UNITED STATES PATENT AND TRADEMARK OFFICE

10/028,419

Office Action Summary	Application No.		Applicant(s)	
	10/028,419		VANNIASINKAM ET AL.	
	Examiner		Art Unit	
	Kianni C. Kaveh		2883

Claims 1-15 and 23 are rejected under 35 U.S.C. 103(a) as being unpatentable over Kramer (US 6583934).

FIGURE 6

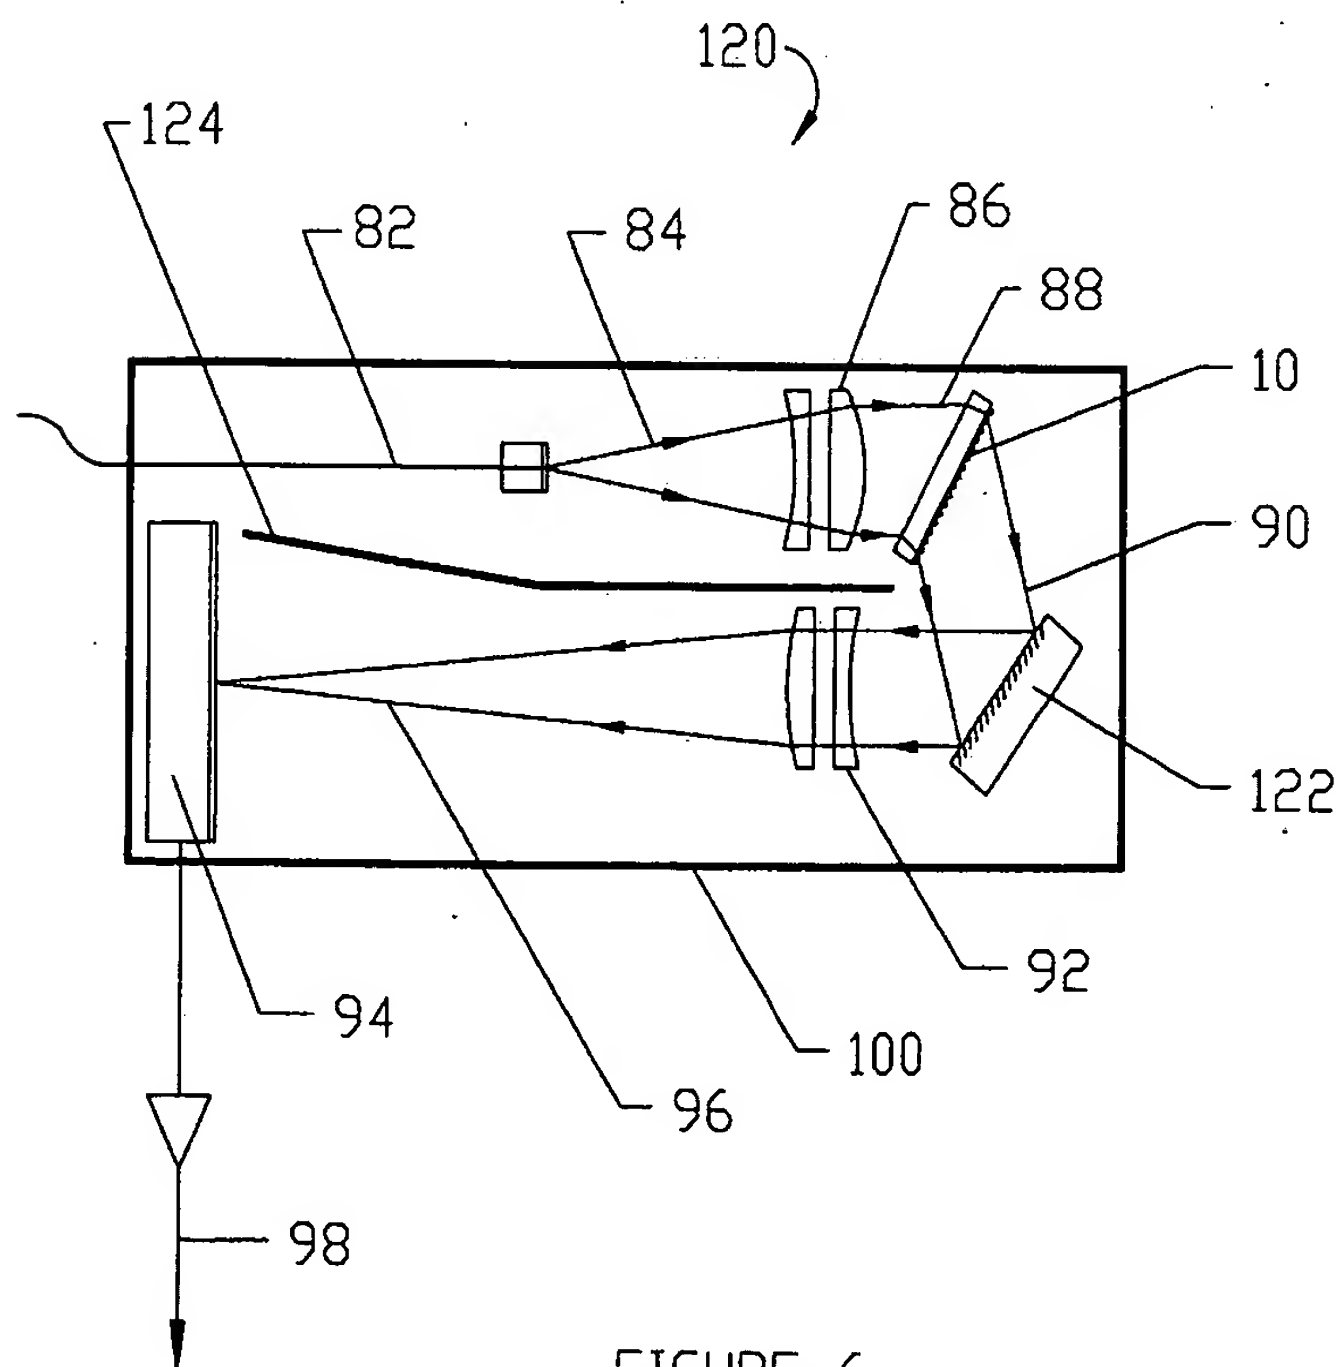
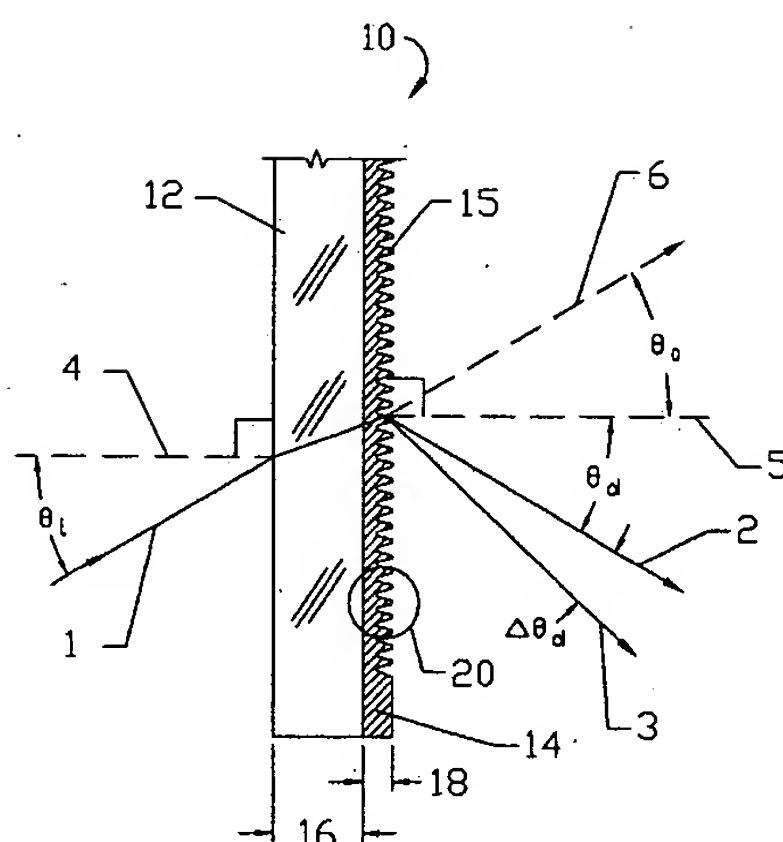
A single integrated piece (shown in at least fig. 6) comprising an integrated first section, second section, third section, and diffraction grating (shown in fig. 6, the sections are integrally formed as a single piece in a housing 100),

The first section capable of receiving a WDM beam (see fig 1 and 6, item first section having grating **15** for receives WDM beam; see also col. 13, lines 48-52), the diffraction ***grating 15 integrally formed on an external surface of the first section (shown in fig. 1)*** of the single molded piece (shown in fig. 1, item diffraction **grating 15**

integrally formed in the first section), the WDM beam 88 being directed onto the internal surface of the diffraction grating 10 (shown in fig. 6, item 10 receives WDM beam), the diffraction grating/means providing angularly separated beams $\lambda_1.. \lambda_3$ on the external surface of the diffraction grating 15;

the third section positioned relative to the first section to receive spatially separated light beams of a selected diffraction order $\lambda_1.. \lambda_3$ from the diffraction grating 15 (shown in fig. 6, item third section receives spatially separated light beams of a selected diffraction order $\lambda_1.. \lambda_3$ from the diffraction grating 15);

combinations will be apparent to those skilled in the art (see col. 16, 3rd parag.). The examiner does not give patentable weight to the limitation '**molded**' since the word 'molded' implies that the above demultiplexer was made through molding process. The device multiplexer is a product claim and what is important is the integrated product itself and how it functions not how or which process was used to make it (see MPEM 2144.04); further, the presence of process limitations on product claims, which product does not otherwise patentably distinguish over prior art, cannot impart patentability to the product *In re Stephens*, 145 USPQ 656 (CCPA 1965). See also 2113 Product-by-Process Claims: "[E]ven though product-by-process claims are limited by and defined by the process, determination of patentability is based on the product itself. The patentability of a product does not depend on its method of production. If the product in the product-by-process claim is the same as or obvious from a product of the prior art, the claim is unpatentable even though the prior product was made by a different process." *In re Thorpe*, 777 F.2d 695, 698, 227 USPQ 964, 966 (Fed. Cir. 1985) (citations omitted) (Claim was directed to a novolac color developer. The process of making the developer was allowed. The difference between the inventive process and the prior art was the addition of metal oxide and carboxylic acid as separate ingredients instead of adding the more expensive pre-reacted metal carboxylate. The product-by-process claim was rejected because the end product, in both the prior art and the allowed process, ends up containing metal carboxylate. The fact that the metal carboxylate is not directly added, but is instead produced in-situ does not change the end product). Thus, It is well known to those of ordinary skill in the art when the invention was made to combine different embodiments of Kramer's teachings such as by replacing the grating 10 with that of double grating 250 in which item 15 functions as a reflector and use a silver coating rather than a gold

or aluminum, and further, as a matter of design choice, place a lens around the support section S aperture (see above figure) of third section in order to construct a demultiplexing system that includes the above limitations, and since such coating would have essentially the same functional effect and since such demultiplexing system would provide a surface relief/aligner transmission grating with improved durability with a highly diffraction efficiency performance (col. 2, lines 21-24 and 57-62).

Regarding Claims 23, Kramer teaches a multiplexing device (shown in at least figure 6 and 28, shown above), comprising:
means for separating an input light beam into constituent parts $\lambda_1.. \lambda_3$ with a single piece component 10 having *a diffraction means 15 on an external surface of the single piece component 10* (see fig. 1 and 6, item single piece component 10 having diffraction means 15);
means 94 for detecting the constituent parts $\lambda_1.. \lambda_3$ from *the single piece component 10*;
means for aligning the means for separating with the means for detecting 94 (see the housing 100, inherently, aligns the first, second and third section and diffraction grating; note that this alignment scheme is analogous to the applicant's aligning means—i.e., as stated in the specification parag. 0034 with regard to alignment of the elements/means in figure 2).
